Project	<b>IEEE 802.16 Broadband Wireless Access Working Group</b> < <a href="http://ieee802.org/16">http://ieee802.org/16</a> >	
Title	<b>Sleep Mode in MR network</b>	
Date Submitted	<b>2007-01-08</b>	
Source(s)	Yuefeng Zhou; Mike Hart; Sunil Vadgama Fujitsu Laboratories of Europe Ltd Hayes Park Central, Hayes End Road, Hayes, Middlesex, UB4 8FE, UK	Voice: +44 (0) 20 8573 4444 FAX: +44 (0) 20 8606 4539 Email: <a href="mailto:Yuefeng.zhou@uk.fujitsu.com">Yuefeng.zhou@uk.fujitsu.com</a> <a href="mailto:Mike.hart@uk.fujitsu.com">Mike.hart@uk.fujitsu.com</a> <a href="mailto:Sunil.vadgama@uk.fujitsu.com">Sunil.vadgama@uk.fujitsu.com</a>
	Keiichi Nakatsugawa Fujitsu Laboratories Ltd. Kamikodanaka 4-1-1, Kawasaki, 211-8588, Japan	Voice: +81-44-754-2811 Fax: +81-44-754-2786 <a href="mailto:nakatsugawa@jp.fujitsu.com">nakatsugawa@jp.fujitsu.com</a>
	Shiao-Li Tsao, Fang-Ching Ren, Wern-Ho Sheen, I-Kang Fu National Chiao Tung University (NCTU) /Industrial Technology Research Institute (ITRI), Taiwan No. 195, Sec. 4, Chung Hsing Rd., Chutung, Hsinchu, Taiwan 310, R.O.C.	Voice: +886-3-5712121-54717 Fax: +886-3-5721490 E-mail: <a href="mailto:sltsao@cs.nctu.edu.tw">sltsao@cs.nctu.edu.tw</a> , <

Figure XX – MR-BS approves of CIDs entering sleep mode

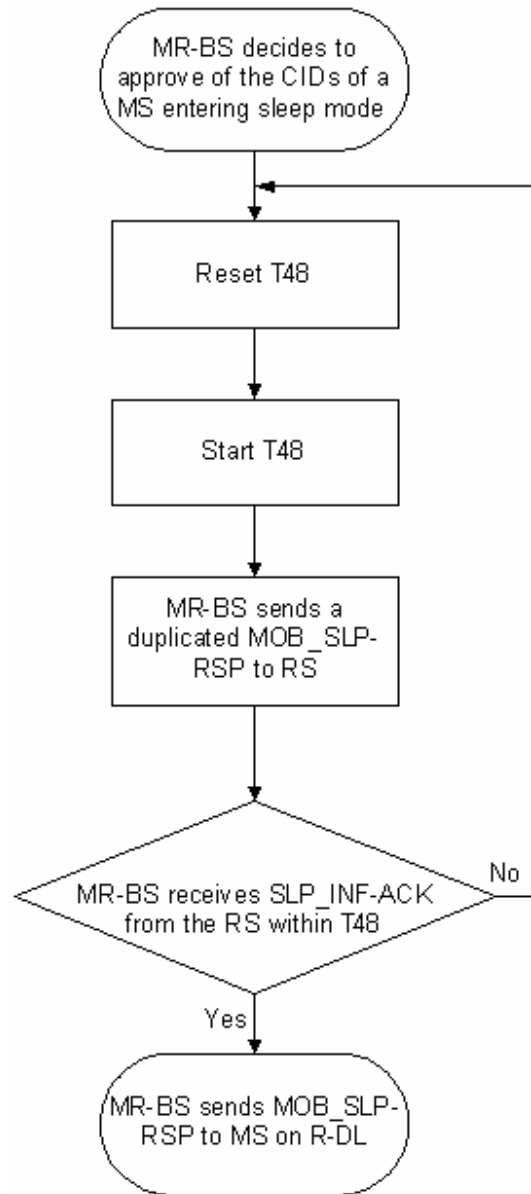
In the distributed scheduling case, the MR-BS shall firstly send a duplicated MOB\_SLP-RSP message to the RS on the RS’s basic CID. After receive the duplicated MOB\_SLP-RSP message, the RS shall send SLP\_INF-ACK message to MR-BS to acknowledge that it got the information about the sleep context of the CIDs indicated. The MB-RS shall retransmit the duplicated MOB\_SLP-RSP message to the RS on the RS’s basic CID, if it does not receive the SLP\_INF-ACK message from the corresponding RS within the T48 timer. Once MR-BS receives the SLP\_INF-ACK message, it shall send a MOB\_SLP-RSP message, which will be relayed by RSs, either in response to a MOB\_SLP-REQ or unsolicited. Fig. XX illustrates the procedure of MR-BS approving of sleep-mode CIDs.
